Proposed SE Elevation

A 110 002 - REV P2

NMA Application
01/11/23

A 110 004 - REV P2

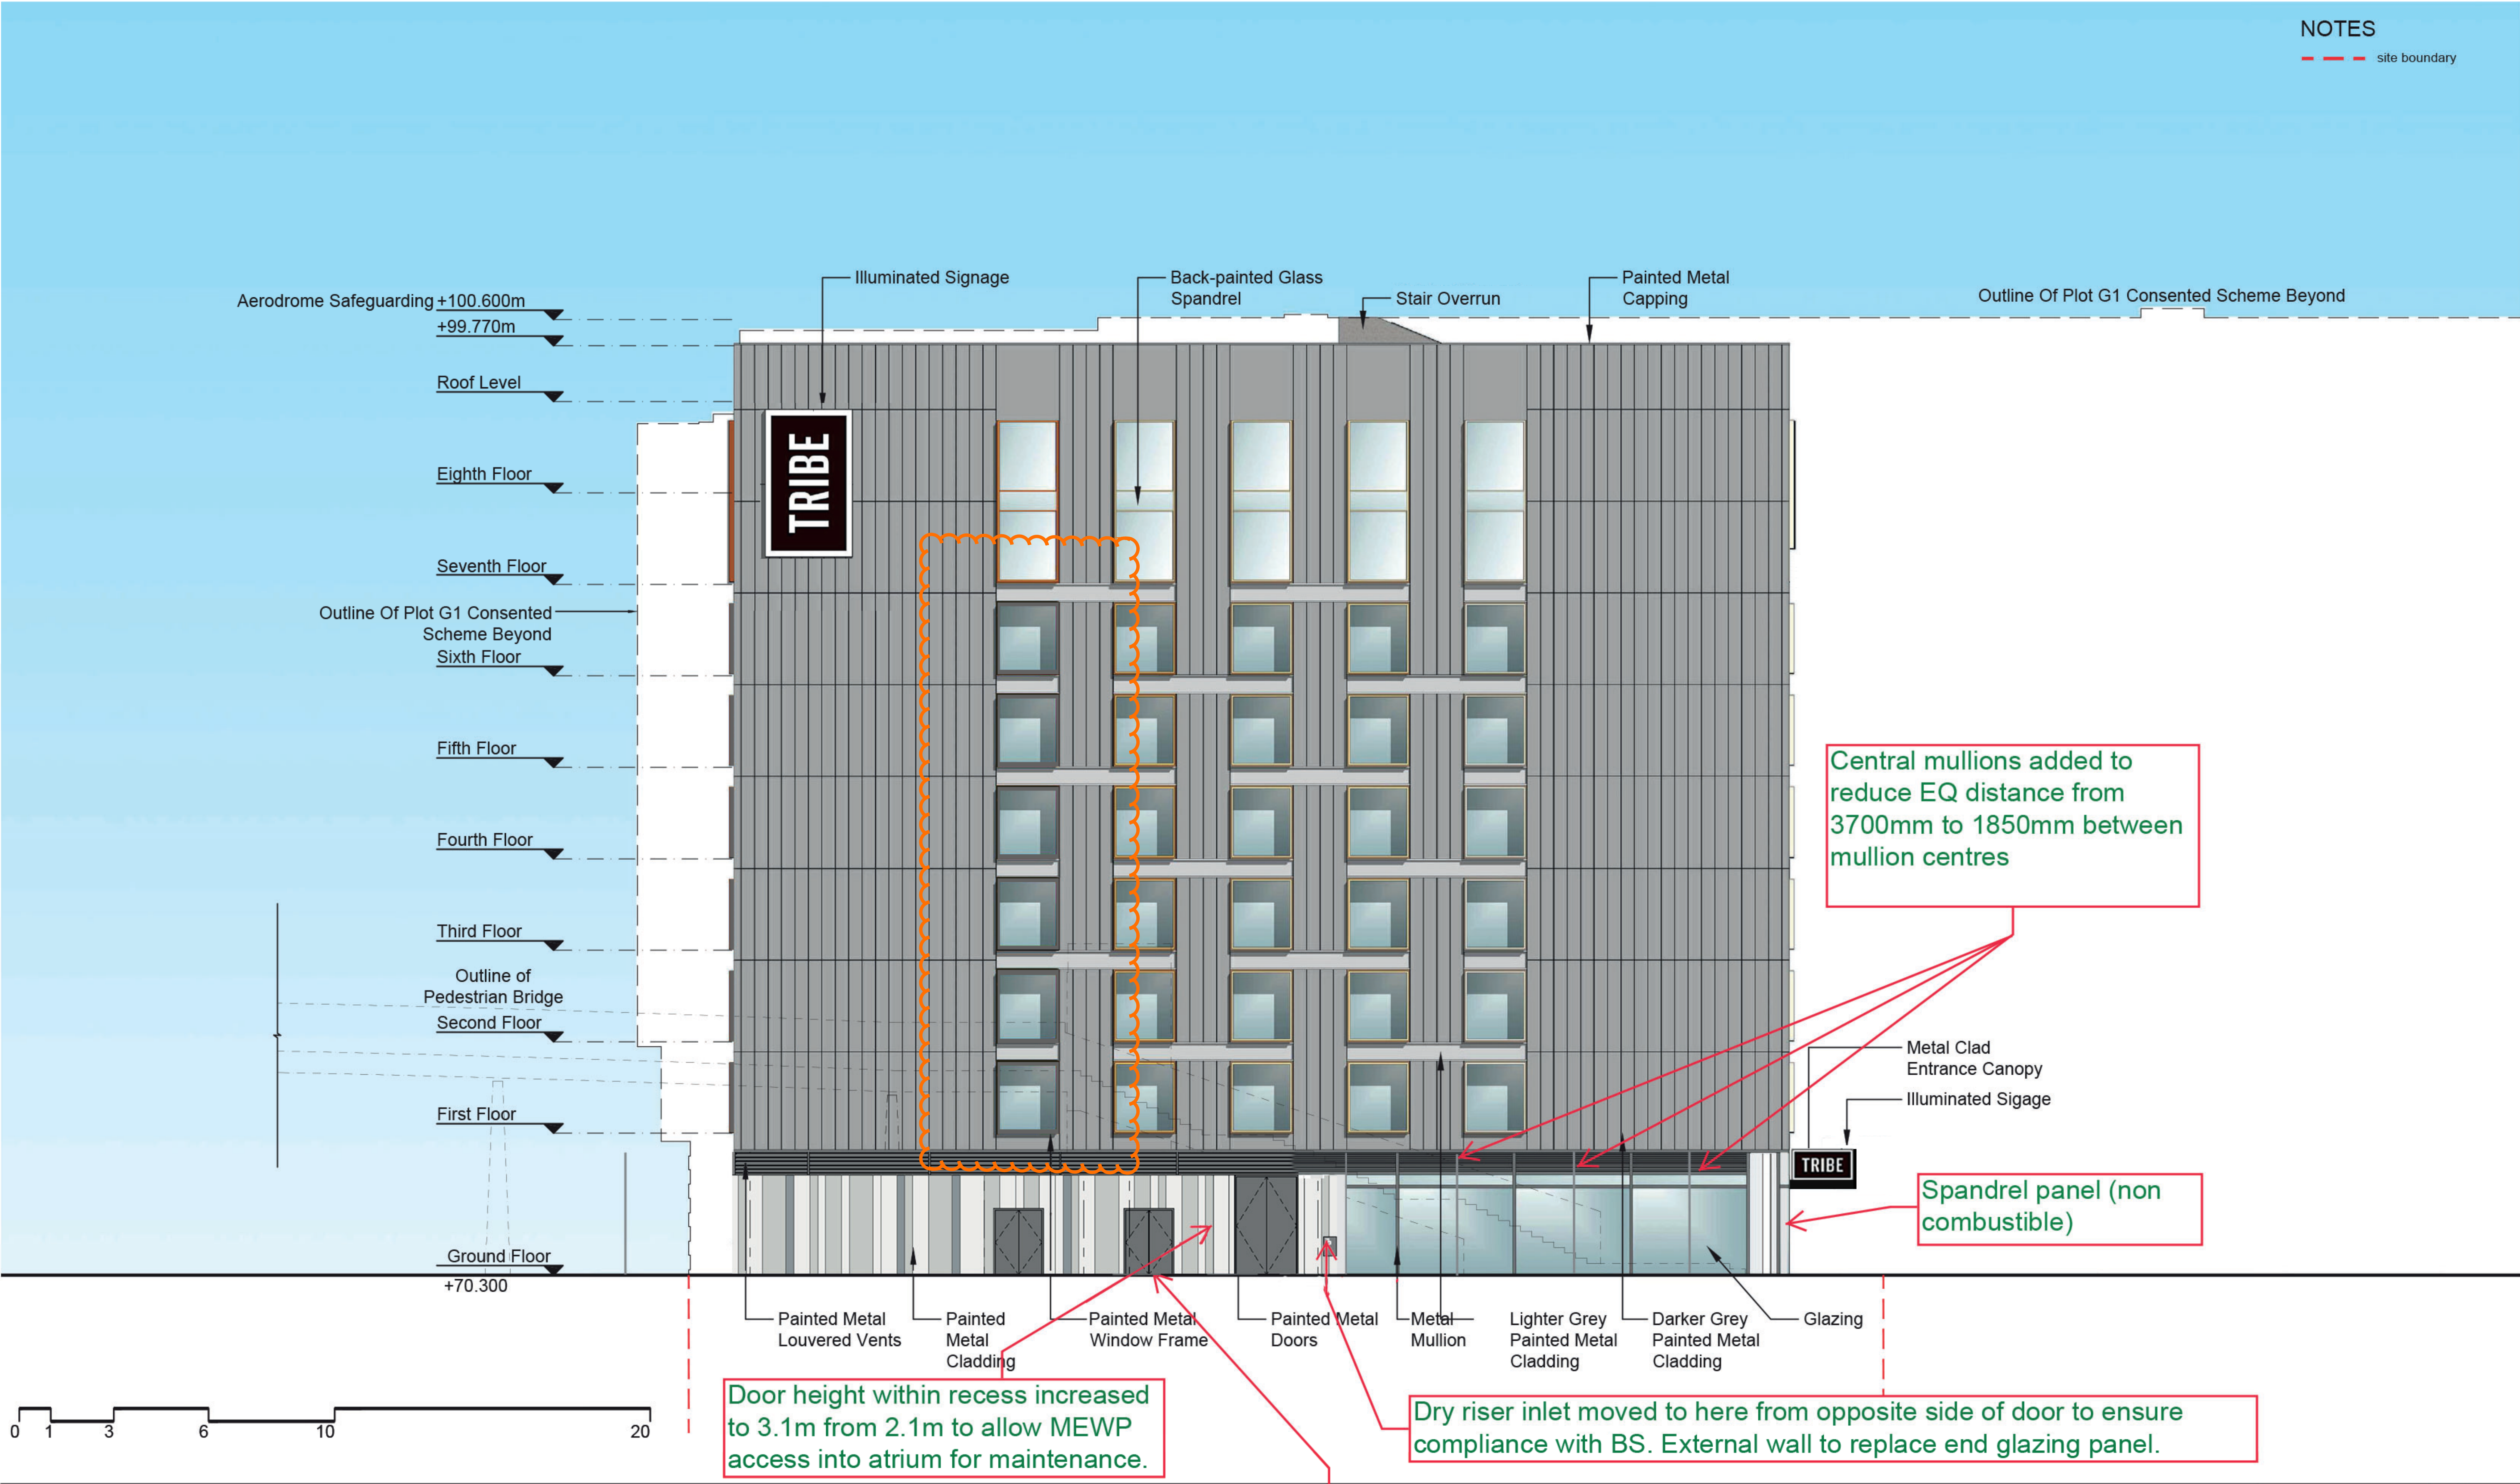
Window surrounds on levels L1-6
changed to grey - RAL 9007
